Revisions to the Cairns Plan Hill Slope and Vegetation Conservation

Save Our Slopes Community Action Group Incorporated
and
Whitfield Hill Community Action Group Incorporated
October 2008
Revision 3

5.1 Ellis Beach – Hillslope # 1 Lot 13 NR5512 & Lot 22SP147762

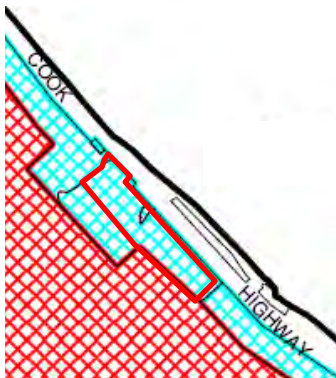
Planning designation inconsistent with identical conservation designation to the north and south. *It should be noted that the planning designation takes preference to Hillslope and Vegetation Categories in court outcomes and without the planning designation being amended to Conservation a high degree of protection is not achieved.*

Conservation

Vegetation Conservation Value

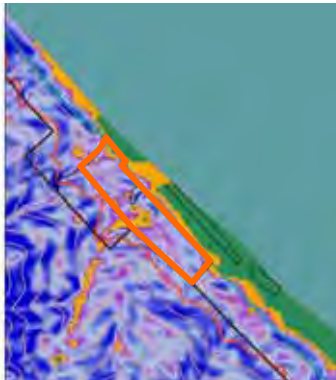
It is noted that in the Cairns Plan Amendment 2007 the Cairns City Council adopted proposal and amended the vegetation Category from Nil to 2

Vegetation Category 1

Terrain Mapping

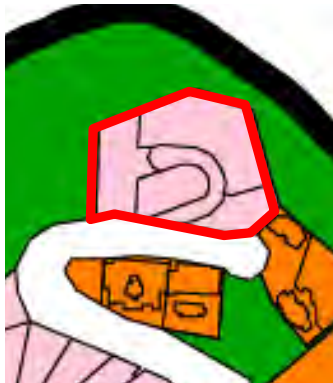
Majority of site (areas indicated in blue tones) have slopes greater than 1:3.

Hillslopes DCP A2.9 states no excavation or filling occurs on land with a gradient that exceeds 1:3. *The Draft Cairns Plan proposed this be increased to 1:4 but the planning designation is in conflict maintaining the site is still suitable for Tourist and Residential development. The risk of failure of erosion and sediment control on slopes this steep is extremely high and the close proximity to the Great Barrier Reef Marine Park increases risk even further.*

5.2 Buchans Point – Hillslope # 2

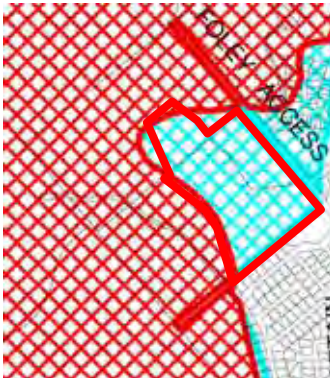
Planning designation inconsistent with identical conservation designation to the north, east and west. Planning designation in conflict with Wet Tropical Coast Regional Coastal Management Plan Key Coastal Site 12 which states the natural scenic value of Buchan Point shall be maintained. This is in conflict with the proposed designation

Hillslopes designated is inconsistent with identical slopes that are designated Category 1.

Majority of site (areas indicated in blue tones) have slopes greater than 1:3.
Hillslopes DCP A2.9 states no excavation or filling occurs on land with a gradient that exceeds 1:3

Conservation

Hillslopes Category 2 (Urban)

5.3 Foley Rd, Palm Cove – Hillslope # 3
 Lot on Plan No's 137RP744021,2RP808351, 1RP808351

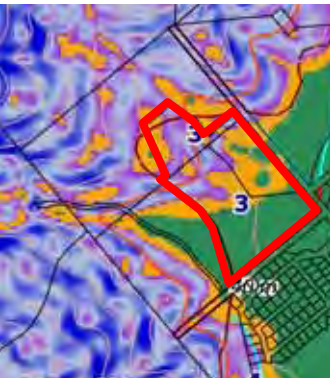
Cairns Plan and Amendment 2007: Tourist and Residential
 Proposed by SOS: **Conservation**
 Comment: Planning designation inconsistent with identical conservation designation to the north and west. Highly visible hillslope from major tourist route. Lower slopes where gradient less than 1:4 maybe suitable for Tourist and Residential designation.

Cairns Plan and Amendment 2007: Hillslopes Category 1 (Urban)
 Proposed by SOS: **Hillslopes Category 2 (Urban)**
 Comment: Hillslopes designated Category 1 are in conflict with designation and adjacent hillslopes. Lower slopes where gradient less than 1:4 maybe suitable for Hillslopes Category 1 (Urban) designation.

5.4 Bokissia Road, Palm Cove – Hillslope # 4

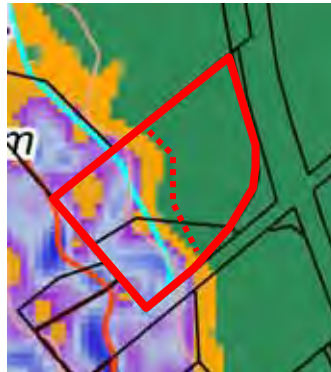
Planning designation inconsistent with identical conservation designation to the north and south. This steep hillslope is particularly visible as it is within 250m of the Captain Cook Highway

It is noted that in the Cairns Plan Amendment 2007 the Cairns City Council adopted proposal and amended the hillslopes Category to 2.

Conservation

Hillslopes Category 2 (Urban)

5.6 Taylor Point – Hillslope # 6

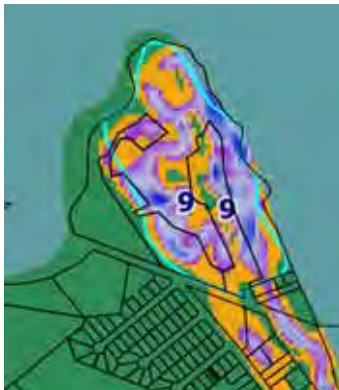
Planning designation inconsistent with identical conservation designation to the north and south. Planning designation in conflict with the Wet Tropical Coast Regional Coastal Management Plan Key Coastal Site 11.4 which states the headland of Taylor Point shall be maintained as natural features. This is in conflict with the proposed designation.

Hillslopes designated Category 1 is in conflict with the Wet Tropical Coast Regional Coastal Management Plan Key Coastal Site 11.4 which states the headland of Taylor Point shall be maintained as natural features. This is in conflict with the proposed designation.

Conservation

Hillslopes Category 2 (Urban)

Special Facilities Zoning

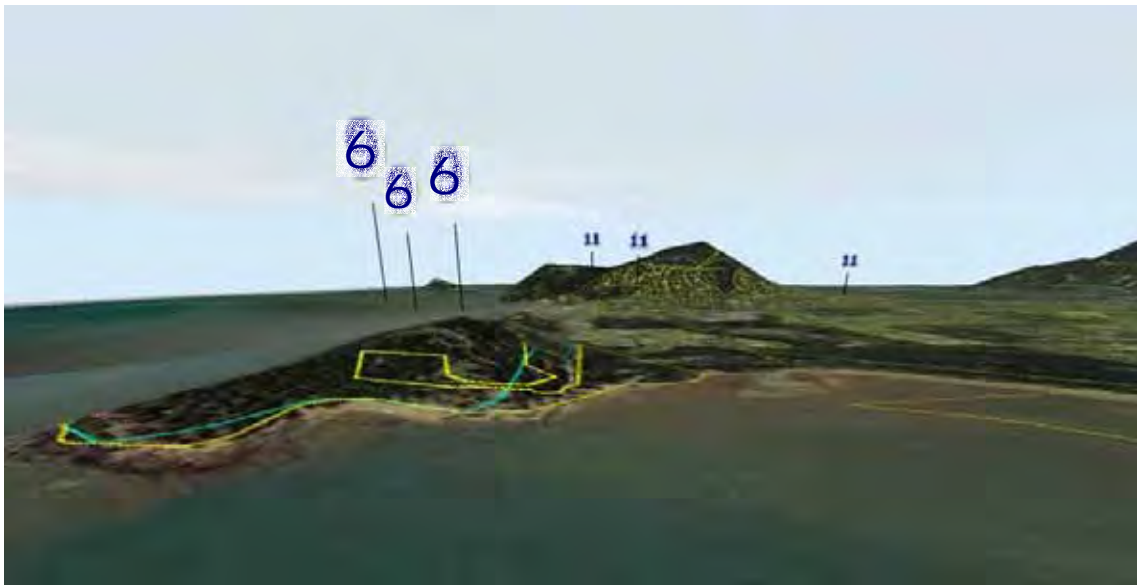
The removal of the existing Special Facilities designation will limit further development that is in conflict with Cairns Plan Desired Environmental Outcomes

Taylor Point visual amenity – proposed designations are in conflict with the Wet Tropical Coast Regional Coastal Management Plan Key Coastal Site 11.4 which states the headland of Taylor Point shall be maintained as a natural feature. This headland is an iconic feature, visible from all directions.

Remove Special Facilities Zoning

5.7 Earle Hill – Hillslope # 7

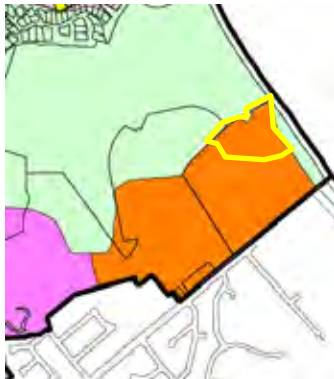
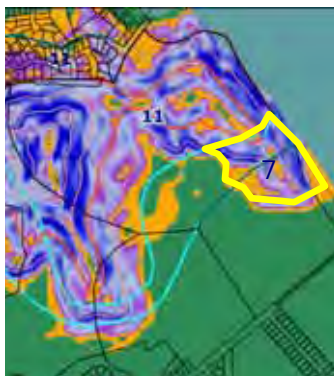
Comment: Highly visible from south and by sea. Planning designation inconsistent with identical slopes of same elevation to the north which is designated conservation. *Amendment 2007 proposes that currently fall within Hillslope Category 1 & 2 designations be designated Conservation. SOS support this proposal*

Comment: Highly visible from south and by sea. Hillslopes Category inconsistent with identical slopes of same elevation to the north which are designated Hillslopes Category 1 (Urban). *Amendment 2007 proposes that Category 1 hillslopes be redesignated Category 2. SOS support this proposal*

Proposed by SOS: **Conservation** - to area marked in yellow

Proposed by SOS: **Hillslopes Category 2 (Urban)** to area marked in yellow

5.8 Kennedy Highway, Smithfield – Hillslope # 8
 Lot on Plan No 154NR6988.

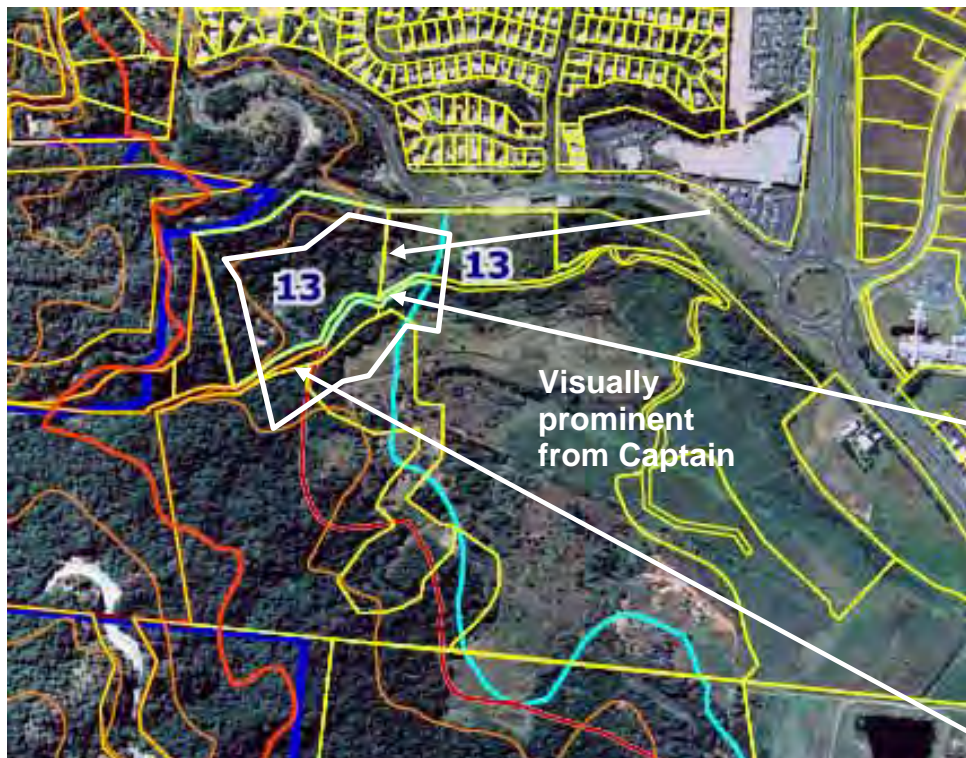
This is on the face of the main mountain range, highly visible from the Kennedy and Captain Cook Highways, from the Smithfield residential area, and from the tourist facilities just south of Smithfield. Any economic gain from the few buildings allowed by the Draft Plan would be outweighed by loss of scenic amenity.

It is noted that in the Cairns Plan Amendment 2007 the Cairns City Council adopted proposal and amended the hillslopes Category to 2 to the upper part of the site

Conservation

Hillslopes Category 2 (Urban)

5.9 Red Peak – Hillslope # 9
 Lot on Plan No 900SP152636

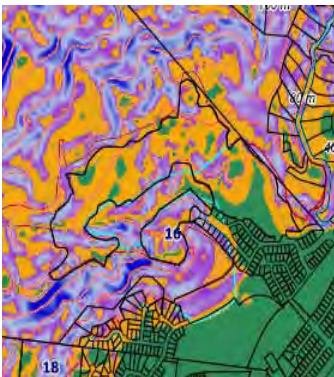
We cannot support 100 persons per hectare 200metres up Red Peak . Construction activity currently visable from a number of lower viewpoints and in particular from #1 Highway. Screening of development required by moving Lots away from edge of hillslope and providing earth bundand landscaping before works begin.

Hillslopes designated Category 1 is in conflict with adjacent Hillslopes Category 2 designation.

Conservation

Hillslopes Category 2 (Urban)

5.10 Stony Creek – Hillslope #'s 19, 20 and 21
 Lot on Plan No 19RP804194, 1RP804194, 5RP804193.

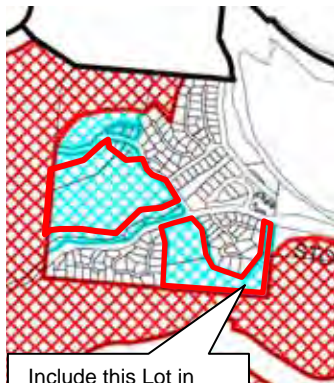
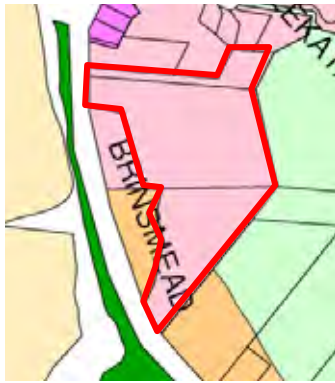
Planning designation inconsistent with identical adjacent designation to the north and south. Lots are steep and cut by numerous gullies and unsuitable for development into housing Lots. Highly significant vegetation would be largely diminished by Residential development designation.

Area visible from Kuranda Train tourist route.

Include this Lot in Hillslopes Cat 2 also

Vegetation is of same quality as adjacent Wet Tropics conservation area. Area more suited as extensions of existing conservation areas than Res.

Conservation

Hillslopes Category 2 (Urban)

5.11 450 – 454 Brinsmead Road, Freshwater – Hillslope #'s 23 & 24
 Lot on Plan No 2RP724523, 2RP726694.

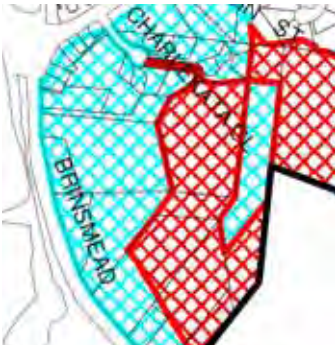
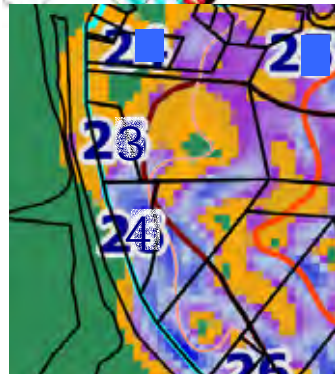
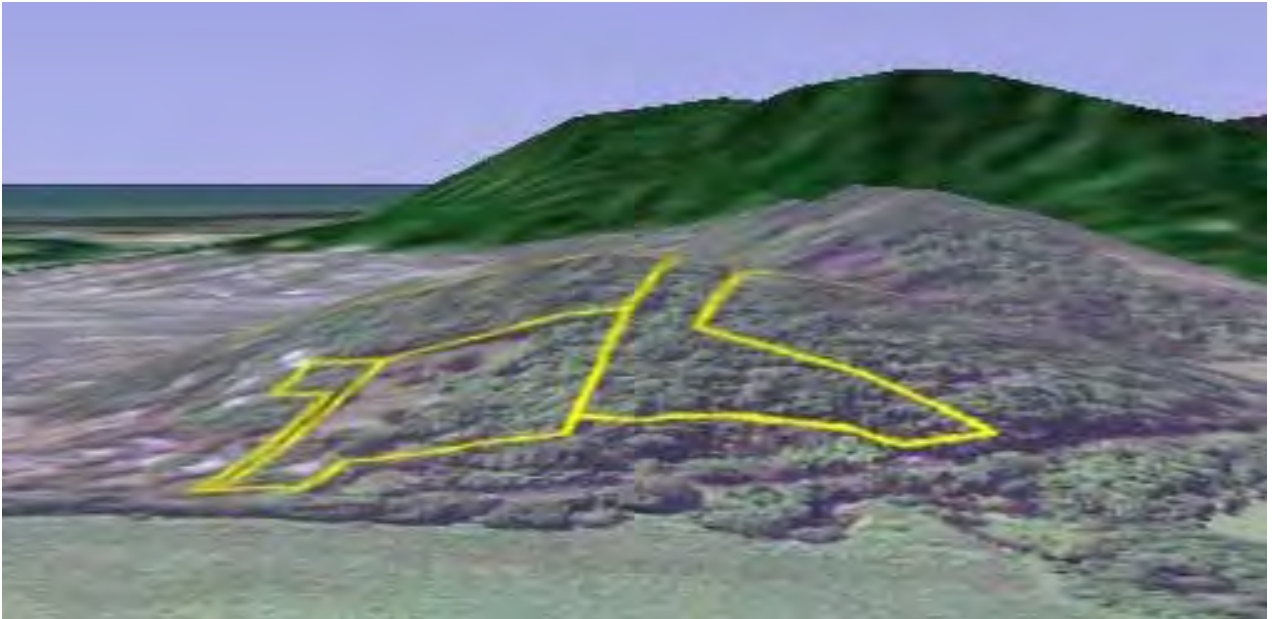
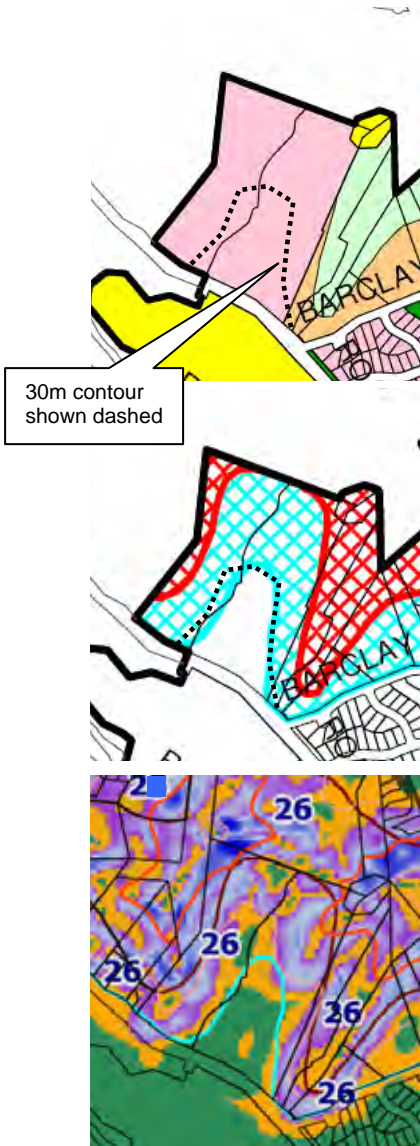
Seep highly visible hillslope with high conservation value. R1 designation will lead to severe reduction in current high visual amenity status contrary to Cairns Plan DEO's. Lower Lot is more appropriately designated LD Res. Lower LD designation illustrates inconsistency of upper lots designations.

Highly visible hillslope from Cairns Western Arterial Road. Refer photograph below.

Rehabilitation of areas of highly visible hillslope more in keeping with Cairns Plan intent

DCDB draped on Google Terrain image indicating visual impact of proposed designation. Residential 1 designation will ensure visual amenity of this key hillslope is reduced – refer section 8 of this report – ‘Review of House Visibility in existing Cairns Hillslope Developments.

DCDB transferred onto actual photograph taken from main highway showing visual impact of proposed Residential 1 designation. Refer photograph 9 of hillslope # 22 (previous hillslope) of impact of Residential 1 designation on prominent hillslopes. Local Law 24 Clause 22 ensures 6m clearance of vegetation around houses resulting in total removal of vegetation on Residential 1 Lots.

Conservation

Hillslopes Category 2 (Urban)

5.12 Brinsmead – Hillslope # 25 & 26
 Lot on Plan No 2RP741238, 3RP741238.

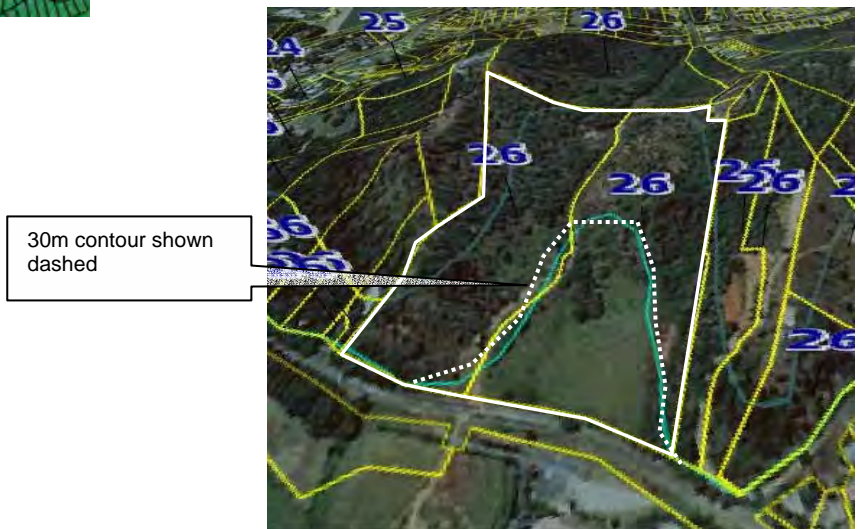
Cairns Plan and Amendment 2007:	Residential 1
<i>Proposed by SOS:</i>	Conservation & Residential 2
Comment	Hillslopes above 30m contour are highly visible from the Western Arterial Highway. Slopes above 30m contour to be designated Conservation. Slopes below 30m contour to be designated Residential 2.

Cairns Plan:	Hillslopes Category 1 (Urban)
<i>Proposed by SOS:</i>	Hillslopes Category 2 (Urban)
Comment	Hillslopes above 30m contour are highly visible from the Western Arterial Highway. Slopes above 30m contour to be designated Hillslopes Cat. 2. Slopes below 30m contour to be designated Hillslopes Cat. 1 <i>Amendment 2007 proposes 50m contour be adopted – SOS reiterate 30m contour more appropriate due to visibility from the Western Arterial Highway</i>

Majority of site above 30m contour has slopes greater than 1:3. Hillslopes DCP A2.9 states no excavation or filling occurs on land with a gradient that exceeds 1:3

5.13 West Redlynch – Hillslope # 27

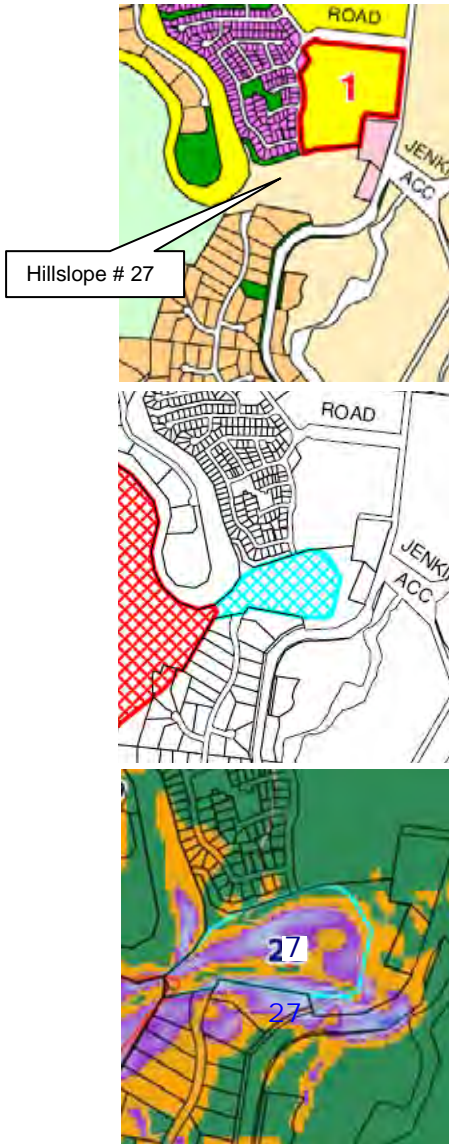
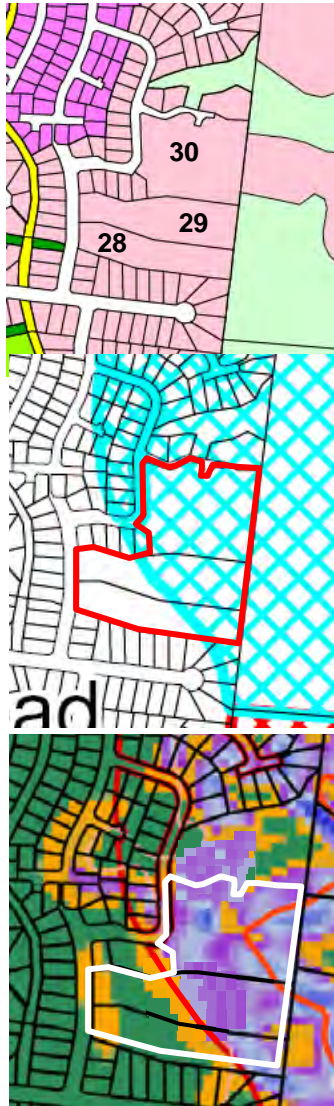
Highly visible hillslope from Intake Road and Kuranda scenic tourist railway.

Where Hillslopes designated Category 1 amend designation to Category 2 as hillslope is highly visible hillslope from Intake Road and Kuranda scenic tourist railway.

Majority of site (areas indicated in blue tones) have slopes greater than 1:3.

Conservation

5.14 Whitfield / Brimsmead - Hillslopes #'s 28, 29 & 30

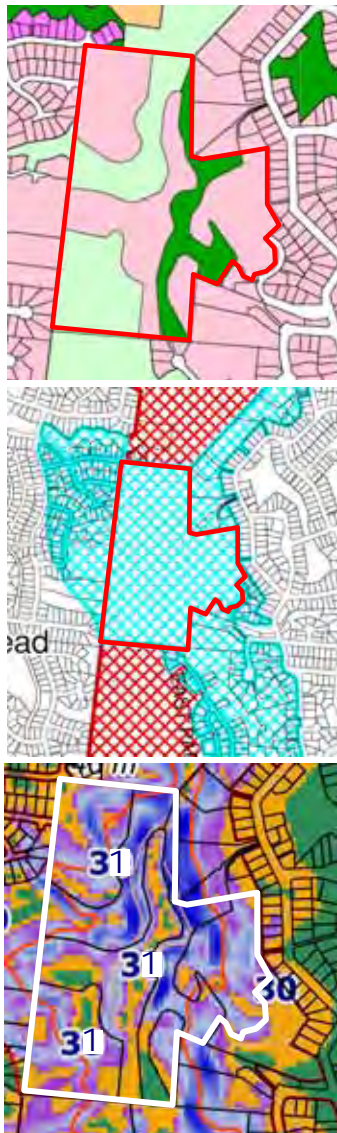
Cairns Plan and Amendment 2007:	Residential 1
Proposed by SOS:	<i>Areas of remaining vegetation to be designated Conservation</i>
Comment	All three hillslopes have areas of high visual amenity and vegetation quality. Highly visible from the Western Arterial Highway.

Cairns Plan:	Hillslopes Category 1 (Urban)
Proposed by SOS:	Hillslopes Category 2 (Urban)
Comment	<i>It is noted that in the Cairns Plan Amendment 2007 the Cairns City Council proposed to amend the 3SP160323 Hillslope above the 50m contour to Category 2.</i>

5.15 Whitfield Hill – Hillslope # 31
 Lot on Plan No RP 730251

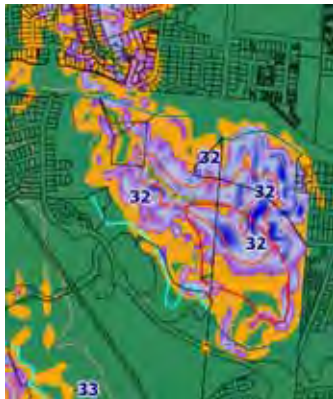
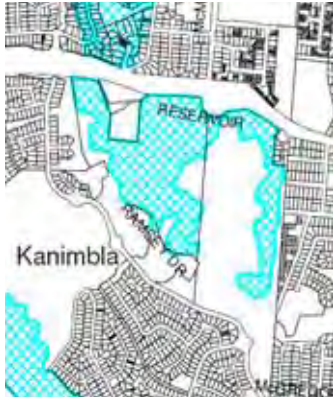
Cairns Plan: Residential 1, Conservation & Open Space
 Proposed by SOS: **Conservation**
 Comment: This is the slope and ridge rising from 50m to 130m. It is immediately above residential areas, with gradients greater than 1 in 3. It is conspicuous from the central part of Cairns to the Esplanade. It extends the visual amenity of Mt Whitfield southwards contributing to the green backdrop of Cairns. Highly visible from the Western Arterial Highway. *Minor redesignation of western steep slope to conservation in Amendment 2007. SOS propose entire hill be redesignated Conservation.*

Cairns Plan Hillslopes Category 1 (Urban)
 Proposed by SOS: **Hillslopes Category 2 (Urban)**
 Comment: Present category 1 designation conflicts with code in regards to developing on ridges / hilltops. Category 2 designation is not in conflict with code and is the only designation that will give robust protection.

This slope is renowned for its instability and slips occur regularly. Planning for absence of disturbance reassures inhabitants of the substantial residential areas below the ridge that the risk of landslide and erosion is taken seriously.
